143rd Street Phase I Engineering Study - Response to Questions

This document provides responses to questions posed to the project team during the 143rd Street Phase I Engineering Study, including the Public Information Meeting held on December 17, 2020, which presented the preferred improvement design for public review and comment. All materials presented at the Public Information Meeting were posted on the Public Information Meeting website at www.143rdStreetProject.com. Additional information can be found about the project throughout the duration of project development on the Village’s project webpage at: <https://www.orlandpark.org/departments/engineering-programs-and-services/143rd-street-widening-project>. If there are any additional questions pertaining the project, you can reach out to the Village of Orland Park Engineering Programs and Services at 708-403-5003 or at eps@orlandpark.org.

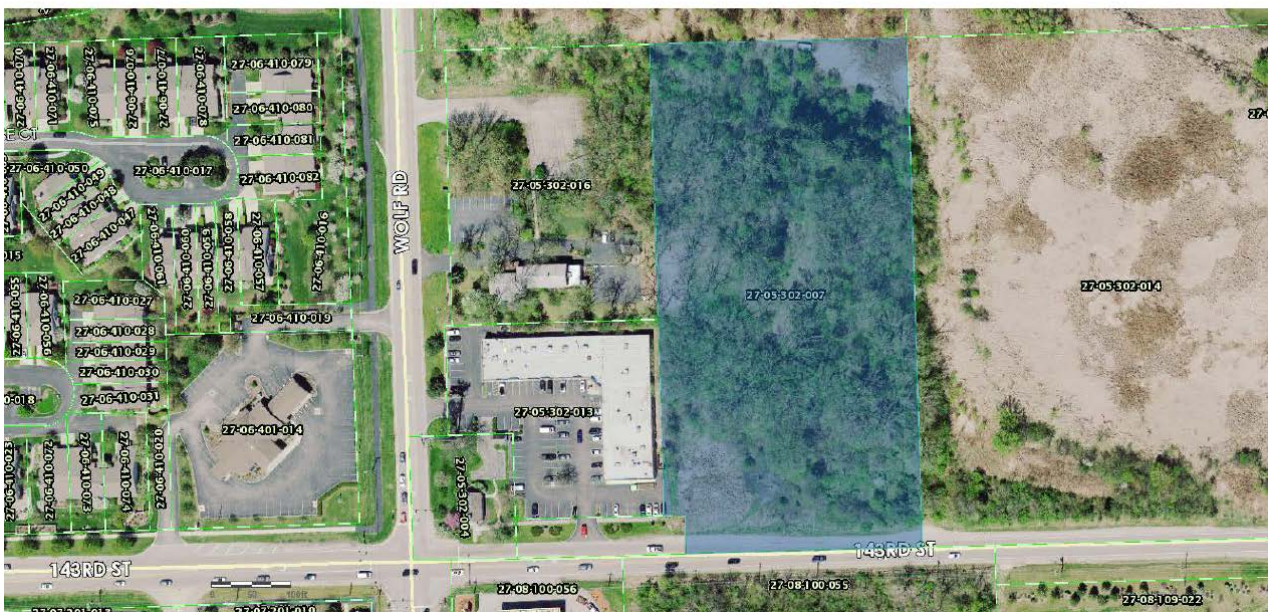
24. What are the Long Run Creek floodplain compensatory storage requirements?

The proposed roadway improvement requires 1.19 acre-feet within the normal water elevation to 10-year flood elevation and 8.39 acre-feet within the 10-year and 100-year flood elevations. The regulatory requirements break the fill in the floodplain into two categories, normal flood elevation to the 10-year flood elevation and

from the 10-year flood elevation to the 100-year flood elevation. Evaluation of the fill of the proposed improvement within these two elevation ranges is conducted, and mitigation is provided accordingly. Per the Village requirements, a 1.5 compensation factor is included to help improve existing stormwater flooding. The floodplain mitigation will be permitted through the Metropolitan Water Reclamation District of Greater Chicago (MWRDGC).

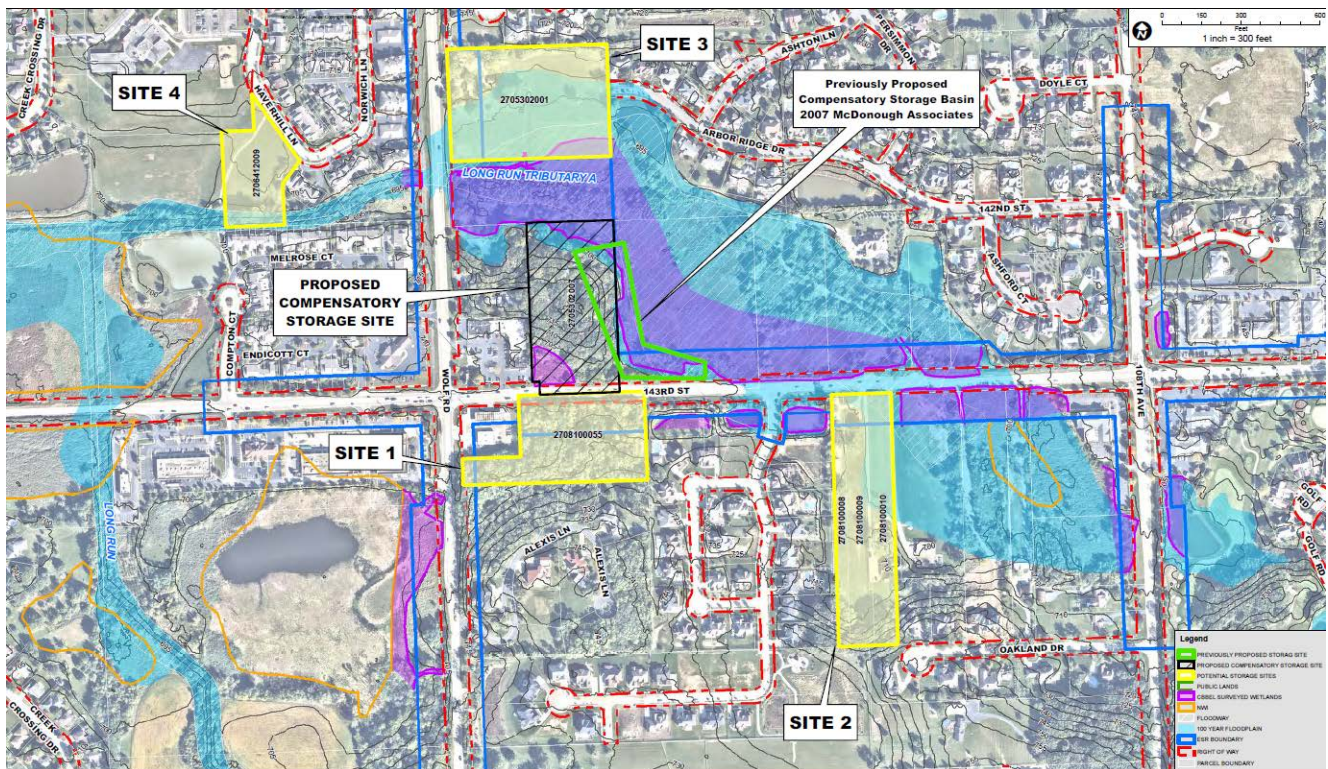
26. What other compensatory storage sites were considered?

Following the December 2020 Public Information Meeting, concerns were raised by stakeholders about use of the Village owned parcel for the proposed compensatory storage site, which is forested with some mature, specimen trees. The Village re-evaluated other potential options for the compensatory storage site. A total of four alternative sites were further evaluated (in yellow) that had possible connection to the Long Run Creek floodplain (light blue). The below exhibit also shows the prior 2007 compensatory storage site in green and currently proposed site in black hatch. The light blue areas is floodplain, purple area is delineated wetland, and dark blue boundary is the project environmental survey boundary.

Below is a summary of main conclusion points from the alternative compensatory storage site assessment:

- None of the four site alternatives singularly provide the required compensatory storage for the 143rd Street project.
- Site 1 is nearly double the cost per acre-foot as compared to the current site, provides half the compensatory storage needed, and is a highly inefficient. Site 1 is recommended to be dropped from further consideration.
- Site 2 is 0.38 ac-ft from meeting the required compensatory storage (per Village requirements), has a similar cost per acre-foot of compensatory storage to the current site, and has two residential

impacts. Site 2 is recommended to be dropped from further consideration due to the two residential property displacements.

- Site 3 is 1.94 ac-ft short of the required compensatory storage, is an efficient site, is the lowest cost per acre-foot, and has one structure displacement. Site 3 is recommended to be dropped from further consideration due to the one residential property displacement.
- Site 4 is 7.22 ac-ft from meeting the required compensatory storage, is the smallest of all the alternative sites considered, is Village owned, has the second highest cost per acre-foot, and is the least efficient site. Site 4 is recommended to be dropped from further consideration.

The currently proposed compensatory storage site is the only site that provides all the required compensatory storage. This site has no building impacts (as compared to Sites 2 and 3), has the second lowest cost per ac-ft, and is a Village owned site. The current site is recommended to be carried forward as the preferred compensatory storage site location, however, the Village is actively pursuing other acquisitions and improvements along the Long Run Creek to implement the Long Run Creek Watershed-Based Plan. If acquisitions and other Village led improvements occur, it is possible that compensatory storage can be provided within those other sites during the restoration process and compensatory storage could be reduced at the current site.
